DESIGN #	DRAWN BY CP	DART AEROSPACE LTD HAWKESBURY, ONTARIO, CANADA	
CHECKED #	APPROVED #	DRAWING NO. D3166	REV. A SHEET 1 OF 1
DATE 02.07.10		TITLE BASKET HOOP	SCALE NTS
A	02.07.10	NEW ISSUE	
A1	04.04.08	38+/-1 HAS 36.0

D3166-1 BASKET HOOP

DRAWING NO. D3166	TITLE BASKET HOOP	REV A1	DART AEROSPACE LTD ENGINEERING ORDER		D.E.O. NO. D3166-A-2	SHEET NO. 1 OF 1	SCALE NTS
DRAWN AJS	CHECKED <i>[Signature]</i>	MFG. APPR. <i>[Signature]</i>	APPROVED <i>[Signature]</i>		DE APPR. <i>[Signature]</i>		
DATE 08.12.11	DATE 08.12.15	DATE 08/12/15	DATE 08/12/16		DATE 08.12.16

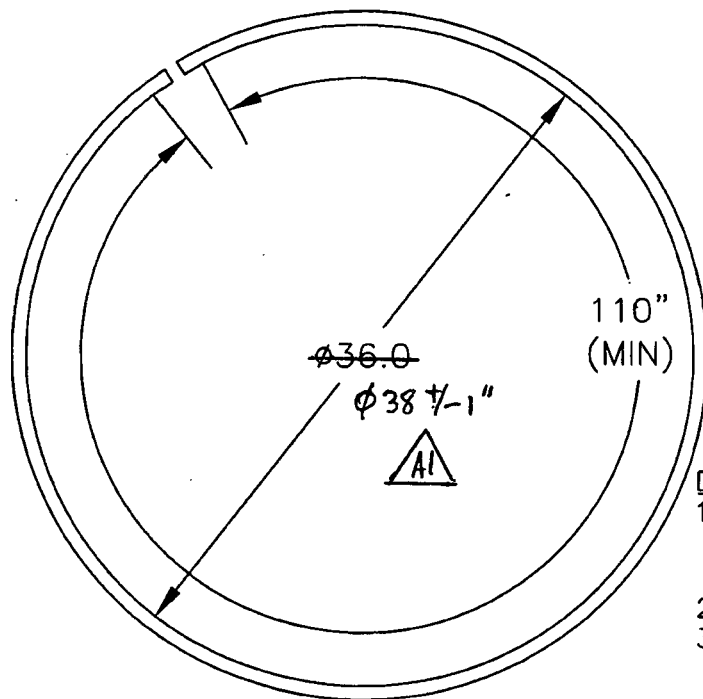
10.6 (REF, NEED 8.0 MIN)

1) MODIFY MATERIAL NOTE FOR D3166-1 AS SHOWN:

1) MATERIAL: AISI 304/316 SS SQUARE TUBING,
0.75" x 0.75" x 0.063 WALL, 60.00" LONG
(REF DART SPEC. M304TS0.750W.063)

2) MODIFY MATERIAL NOTE FOR D3166-3 AS SHOWN:

1) MATERIAL: AISI 304/316 SS SQUARE TUBING,
0.75" x 0.75" x 0.063 WALL, 120.00" LONG
(REF DART SPEC. M304TS0.750W.063)

1) MATERIAL: AISI 304/316 SS, 3/4 X 3/4 X 0.065 WALL SQUARE TUBING,
60.00" LONG
REF. DART SPEC M304TS0.750W.065

1) MATERIAL: AISI 304/316 SS, 3/4 X 3/4 X 0.065 WALL SQUARE TUBING,
120.00" LONG
REF. DART SPEC M304TS0.750W.065
